# Fish Stream Survey Report

Camp Naukati

Stream Name(ID) 103-90-020

Unit 42-11 RP#

Road
Unit Boundary
Unit Boundary Addation
Salmon Stream Temp. Sensative
Blowdown
Proposed Boundary Addation
Sarkar Lake
42-11
B/w
N
5613
5656
42-11
Blowdown
42-12
5600 Road
To Naukati

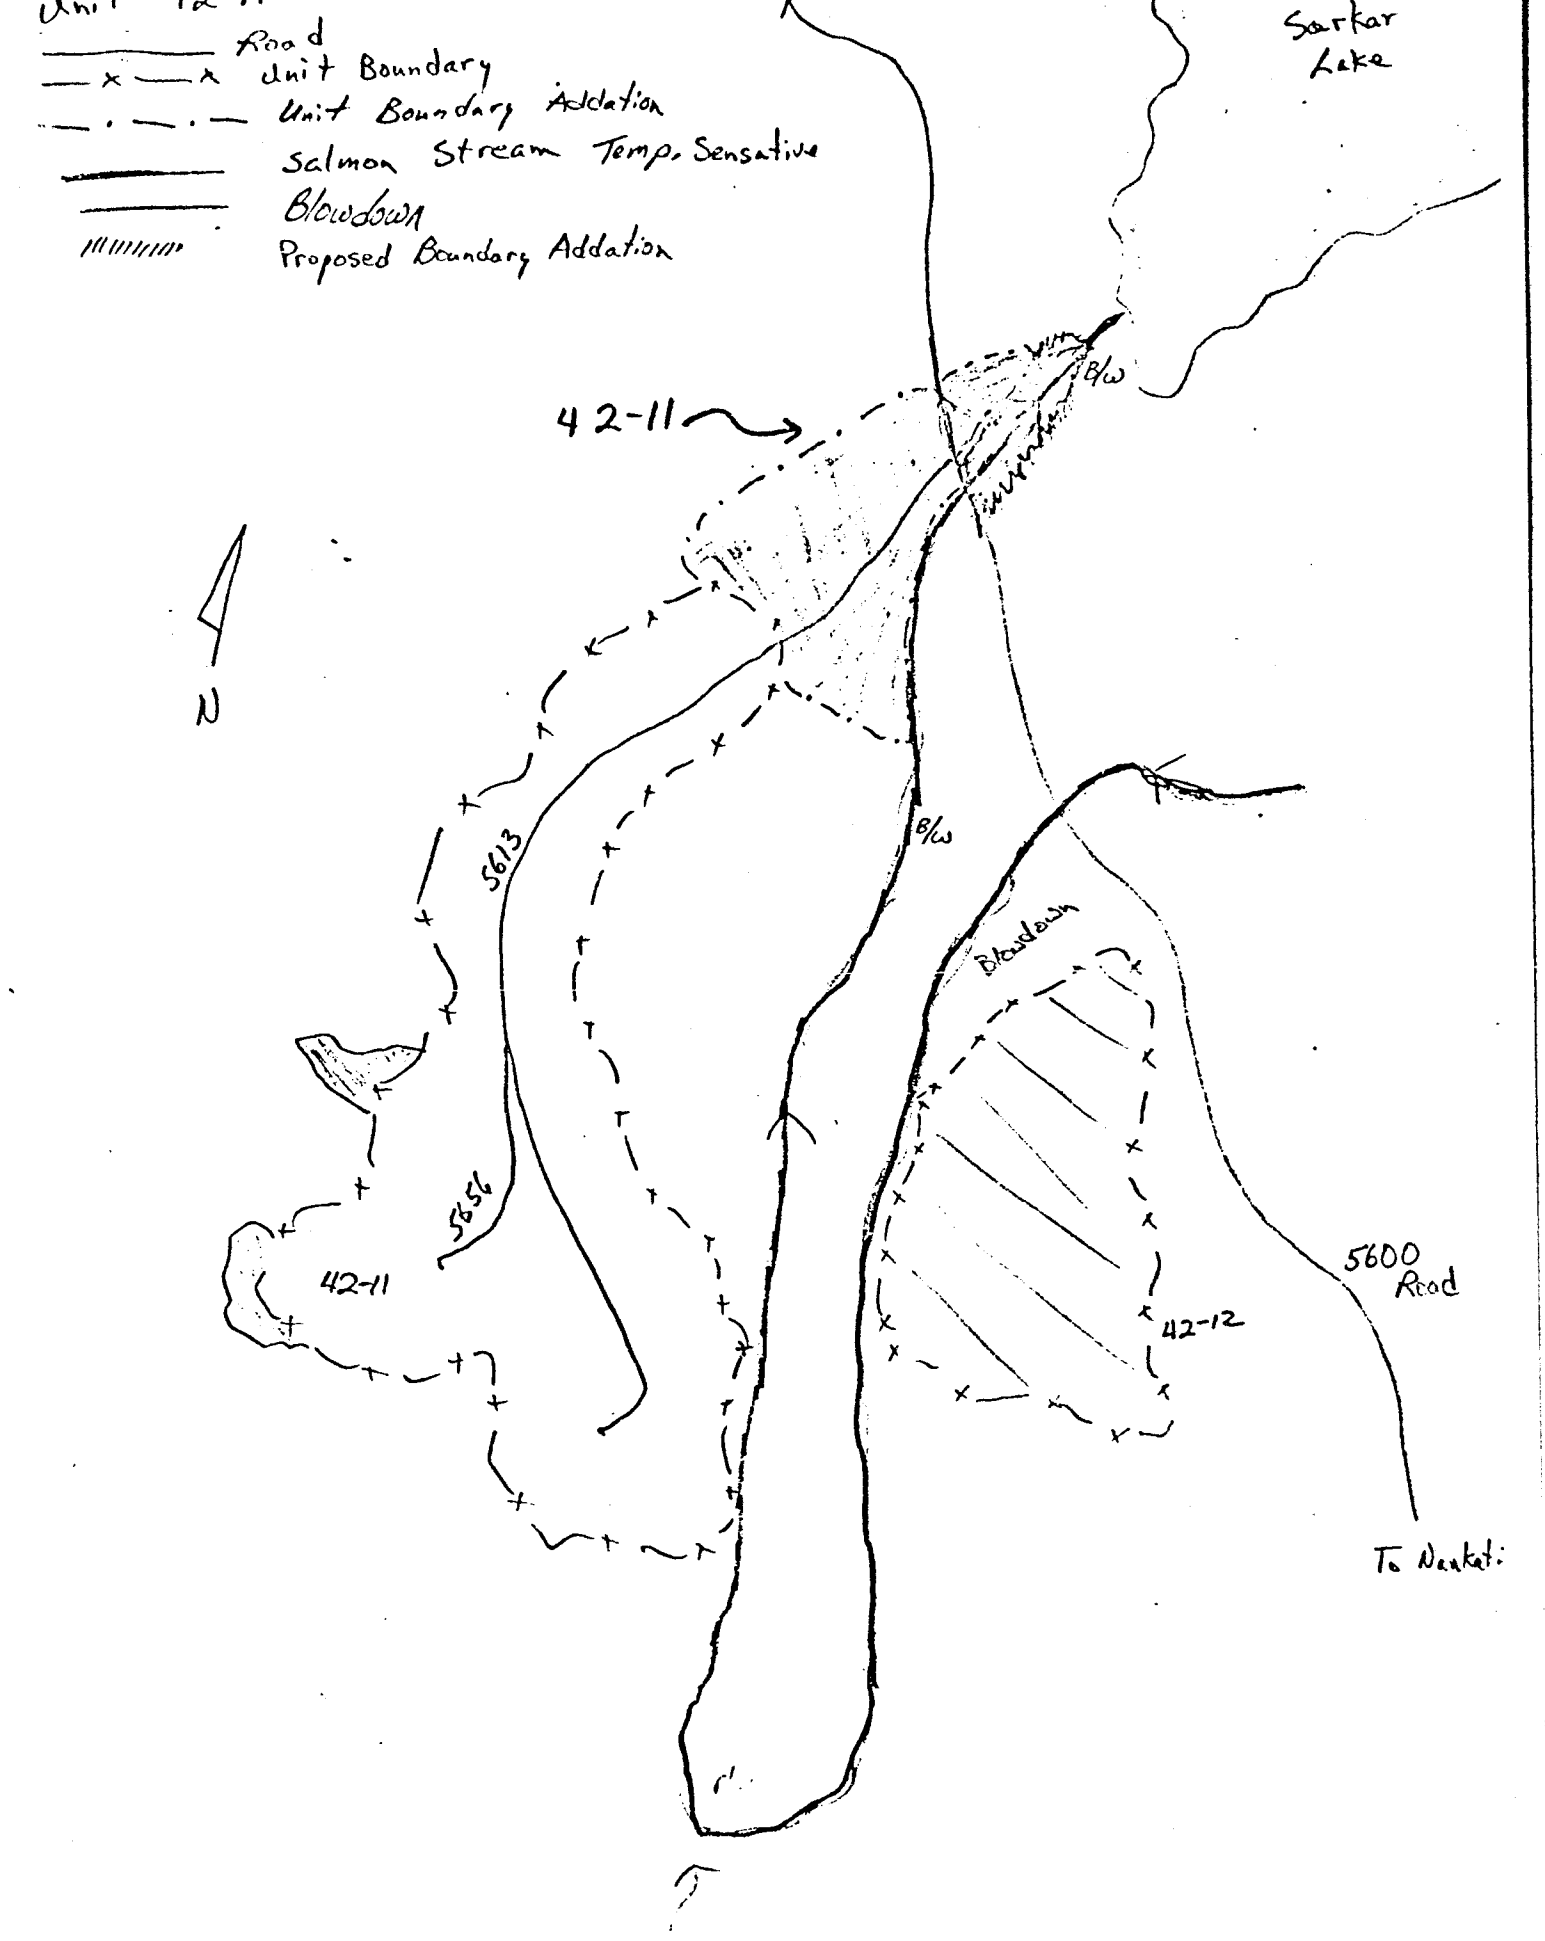
This stream is 10' to 15' wide with 1' to 4' pools and has rock/gravel/sand substrate. This stream has excellent salmon wning/rearing habitate, 90-95% salmon spawning utilization. ere are no tributaries within the unit, the eastern unit boundary e extends to the stream to include the new blowdown the stream. The stream was flagged Blue/White from arkar Lake to 150' south of the stream/unit boundary nction, and tagged above the bridge crossing.

This area has been proposed as a unit to include all the w blowdown west of the 5600 road, and north the stream to Sarkar Lake. There is blowdown in the stream om the southern unit boundary northeast to Sarkar Lake, , most of blowdown in the stream can be yarded y from the stream, so yarding should split on the stream where it is sible. All new blowdown should be removed and the old blowdown ld remain to minimize stream bank disturbance. Debris ld be cleaned up concurrent with logging activities and remaining s along the stream should have directional falling away from the am. The unit boundary should be extended north along the stream approximately 250' at Sarkar Lake to remove all the new blowdown.

's stream should be looked at after logging operations to
if all the new blowdown is removed. This could be a
CC stream cleaning project if the boundary of the unit
not extended towards Sartar Lake.

Recommendations: See attached sheets Note boundary change recommendation include additional blowdown. Blowdown/logging debris should be removed by the operator concurrent with yarding activities. Falling/bucking debris must be removed within 48 hours of deposit Note! Operations should be timed to remove blowdown prior to return of salmon this fall. This stream is temp sensative Fish crews are available to mark blowdown to be left intact. More accurate prescription can be written after blowdown is pickled. Directional falling required for remaining trees along stream. Split on creek or fully suspend over. No bucking or limbing in the creek. Tree length yarded when possible. Buck root wads off on bank when possible Smaller trees (< 24") may be yarded with root wads intact if necessary. Larger root wads should be left in place MN
